## **DOSS FAMILY DIVISION SUBDIVISION**

APPLICATION NUMBER 12 DATE January 16, 2014

APPLICANT Doss Family Division Subdivision

REQUEST Subdivision

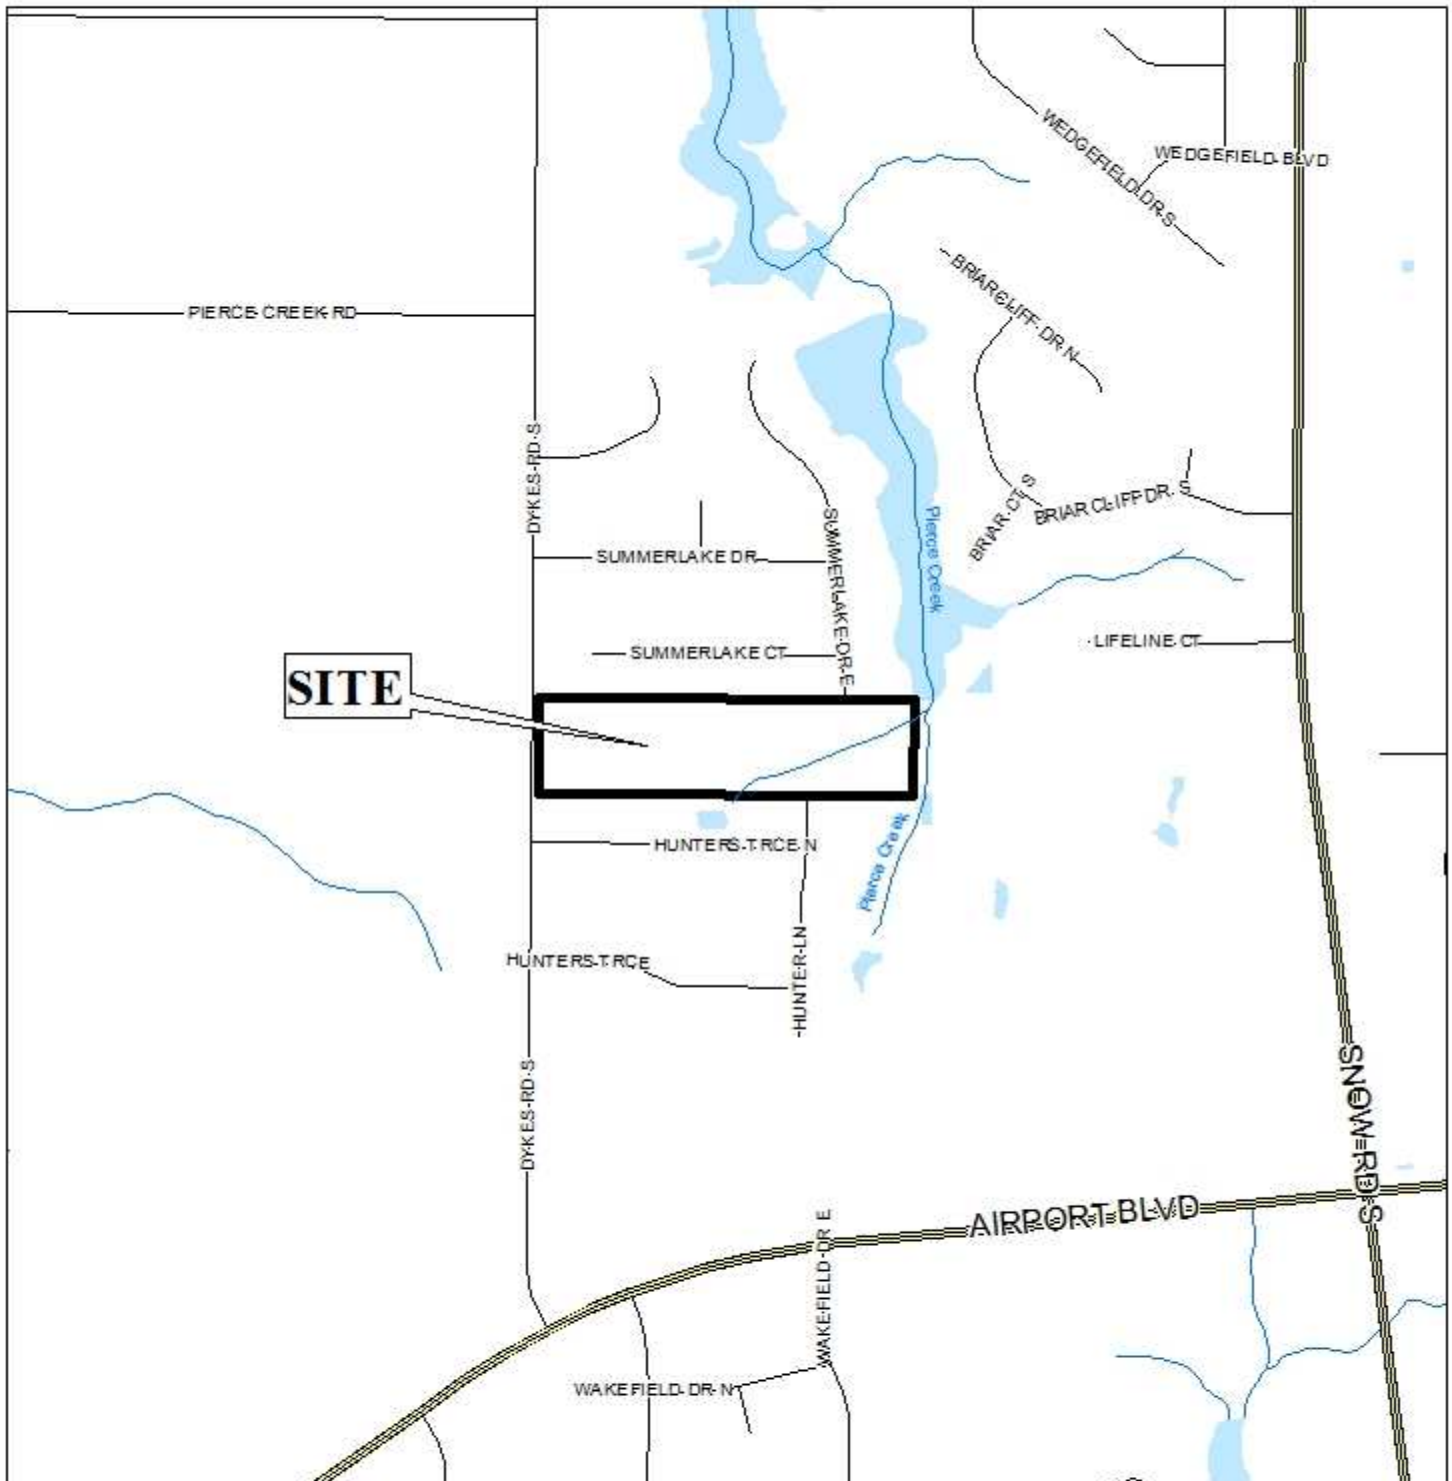
The plat illustrates the proposed 2-lot, 9.8± acre subdivision located on the East side of Dykes Road South, 140'± North of Hunter's Trace North, within the Planning Jurisdiction. The applicant states that the subdivision is served by public water and sanitary services.

The site fronts on Dykes Road South with an adequate 60' right-of-way; therefore, no dedication would be required. Proposed Lot 2 would abut Hunter Lane to the South, with a compliant 50' right-of-way. As a means of access management, a note should be required on the Final Plat stating that Lot 1 is limited to one curb cut to Dykes Road South, and Lot 2 is limited to one curb cut to Dykes Road South and one curb cut to Hunter Lane, with the size, location and design of all curb cuts to be approved by County Engineering and conform to AASHTO standards. Summerlake Drive East to the North of Lot 1 does not extend completely to Lot 1; therefore, a note should be required on the Final Plat stating that Lot 1 is denied access to Summerlake Drive East.

The plat indicates a 25' building setback line from Dykes Road South and this should also be shown on the Final Plat. The plat should be revised to illustrate a 25' building setback line on Lot 2 at the North terminus of Hunter Lane. Both lots meet the minimum size requirements of the Subdivision Regulations and are labeled with their sizes in both square feet and acres on the preliminary plat. The Final Plat should also reflect this labeling, or a table should be furnished on the Final Plat providing the same information.

The site contains NWI wetlands associated with Pierce Creek. The presence of wetlands indicates that the area may be environmentally sensitive; therefore, the approval of all applicable federal, state and local agencies would be required prior to the issuance of any permits or land disturbance activities.

- 1) placement of a note on the Final Plat stating that Lot 1 is limited to one curb cut to Dykes Road South, with the size, location and design to be approved by County Engineering and conform to AASHTO standards;
- 2) placement of a note on the Final Plat stating that Lot 1 is denied access to Summerlake Drive East;
- 3) placement of a note on the Final Plat stating that Lot 2 is limited to one curb cut to Dykes Road South and one curb cut to Hunter Lane, with the size, location and design of all curb cuts to be approved by County Engineering and conform to AASHTO standards;
- 4) retention of the 25' minimum building setback line along Dykes Road South;
- 5) revision of the plat to illustrate a 25' building setback line on Lot 2 at the North terminus of Hunter Lane;
